# Access Compliance Report

## Public Rights-of-Way

### (Curb Ramps)

Intersection ID: 42486	Main Street: ALEXANDER MARTIN_AV	Cross Street: ALMA BLOUNT_BV	Location: NE
ADA ID: 829BBBE6C6E9	Ramp Type: Perp	Initial Pass/Fail: Fail	Overall Compliance: No
Severity Score: 12.5			
Codes/Mitigation Info/Possible Solution		Field Measurements/Component Compliance

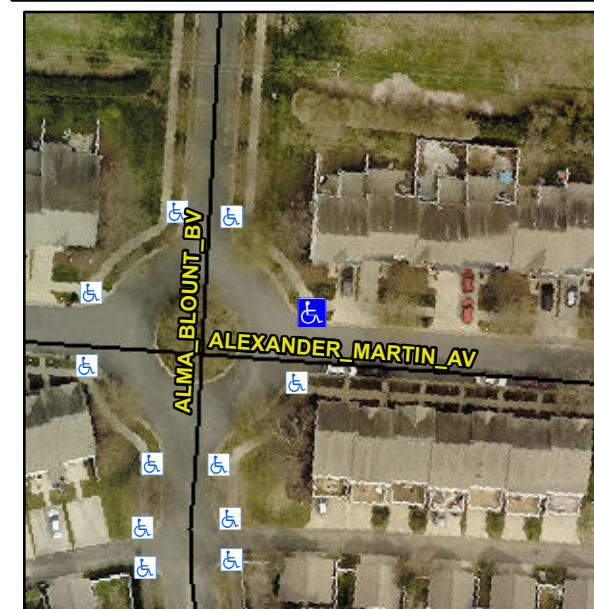
Compliance	Description	Data	Compliance	Description	Data
N/A	Ramp Length (in)	56.0	No	Ramp Slope (%)	9.1
Yes	Ramp Width (in)	48.0	Yes	Ramp XSlope (%)	0.8
N/A	Flare Type LT	N/A	N/A	Flare Type RT	N/A
N/A	Flare Slope LT (%)	N/A	N/A	Flare Slope RT (%)	N/A
N/A	Flare Traversable LT?	N/A	N/A	Flare Traversable RT?	N/A
N/A	Landing Length (in)	N/A	N/A	DWS Provided?	N/A
N/A	Landing Width (in)	N/A	N/A	DWS Contrast?	N/A
N/A	Landing Slope (%)	N/A	N/A	DWS Length (in)	N/A
N/A	Landing X Slope (%)	N/A	N/A	DWS Full Width?	N/A
N/A	Landing Curb? (Y/N)	N/A	N/A	DWS Offset (in)	N/A
N/A	Shared Landing?	N/A			
N/A	Gutter Ponding?	N/A	N/A	Gutter Slope (%)	N/A
N/A	Gutter Lip Ht (in)	N/A	N/A	Gutter X Slope (%)	N/A
N/A	Painted X Walk1?	No	N/A	Painted X Walk2?	N/A
	X Walk 1 Direction	To SW		X Walk 2 Direction	N/A
N/A	X Walk 1 Width (in)	N/A	N/A	X Walk 2 Width (in)	N/A
	X Walk 1 Slope (%)	2.3		X Walk 2 Slope (%)	N/A
	X Walk 1 X Slope (%)	1.9		X Walk 2 X Slope (%)	N/A

N/A	Ramp inside XWalk1?	N/A	N/A	Ramp inside XWalk2?	N/A
	Road Slope (%)	N/A	N/A	Clear Space?	N/A
	Road X Slope (%)	N/A	N/A	Clear Space to XWalk (in)	N/A
N/A	Any Obstructions?	N/A	N/A	Storm Grate/Utility Hazard?	N/A
	Obstruction Type			Storm Grate/Utility Type	
		N/A			N/A
		Yes		Surface Condition? (G/P)	Good

**Remove & Replace Entire Ramp.**

**R304.2.2**
